**LAND INSTABILITY & STORMWATER MANAGEMENT
58 AKORANGA DRIVE, NORTHCOTE, AUCKLAND**

**LAND INSTABILITY & STORMWATER MANAGEMENT – 58 Akoranga
Drive, Northcote, Auckland**

58 Akoranga Drive, Northcote - Screen print from Council GIS

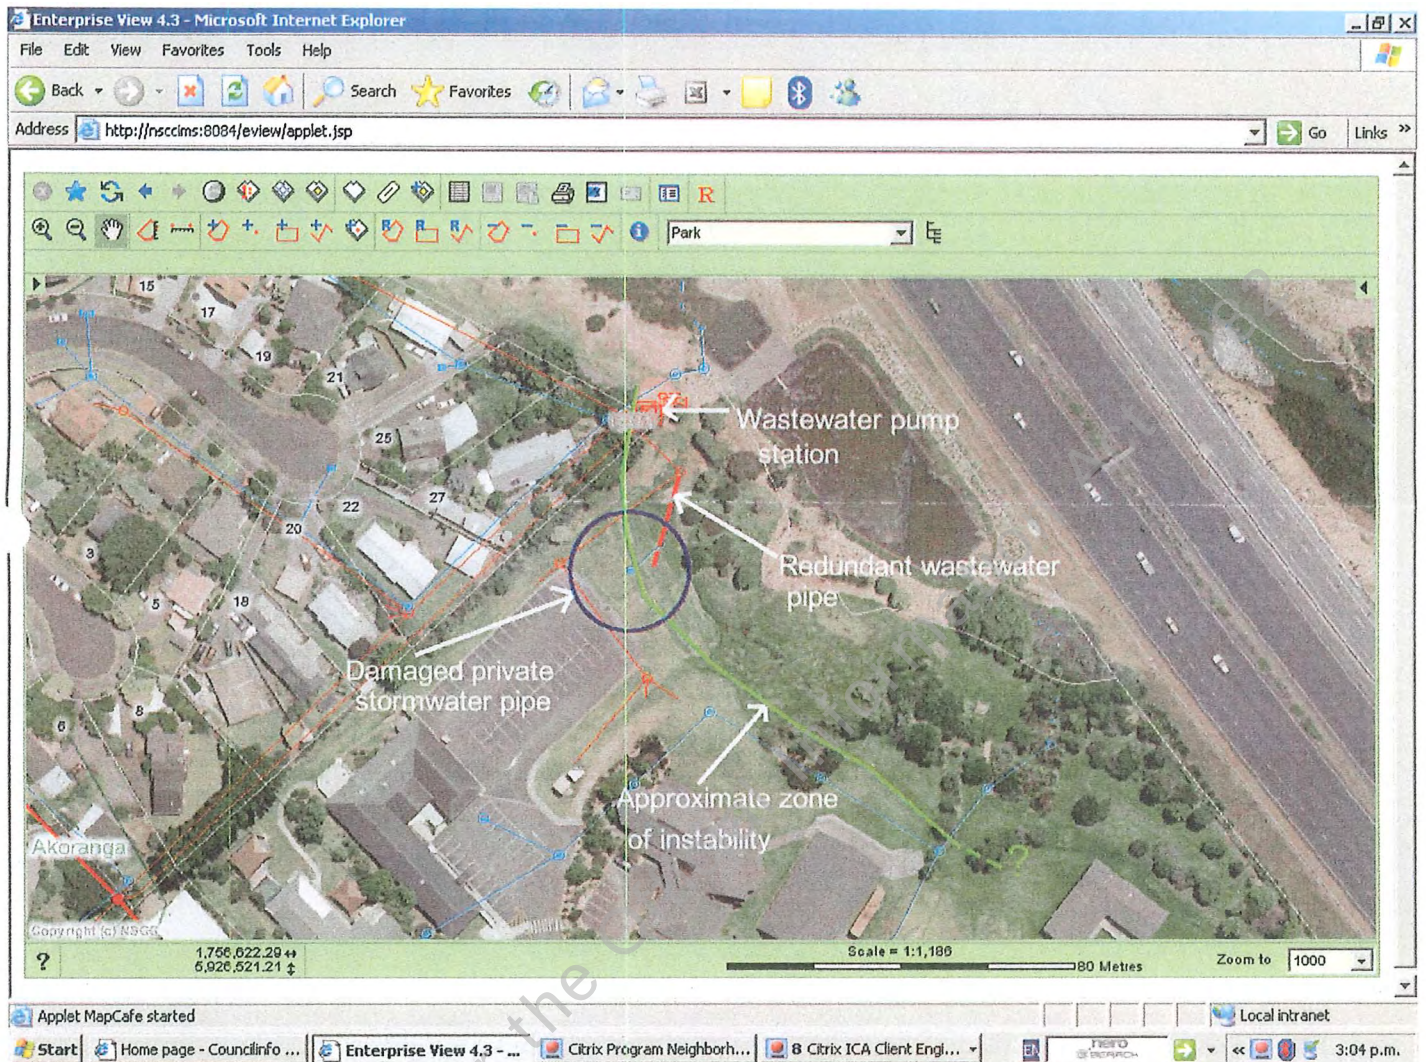
Several public pipes had experienced displacement or collapse. These public pipes have since been repaired. One privately owned pipe (draining the stormwater from the large car park beneath the health centre on 58 Akoranga Drive) was surveyed and was recorded as being damaged. This pipe appears to have been designed to collect rainwater runoff from the car park and discharge it onto the ground surface some distance down slope. A breakage in the pipe in the area of ground instability means that stormwater entering this pipe is being discharged directly into the ground. Stormwater entering the ground in this area may be contributing to the ground movement by acting as a lubricant between soil layers.

Council proposes to cap the redundant wastewater pipe once the DTZ-owned stormwater pipe on your property is fixed. This is a serious issue that needs attending to as a matter of urgency.

The stormwater pipe draining the car park needs to be repaired or redirected away from the area of instability. Your prompt action regarding remediation of the damaged stormwater drainage will be appreciated. Council will assist with advice on appropriate stormwater design (in reference to the issue at hand) if required.
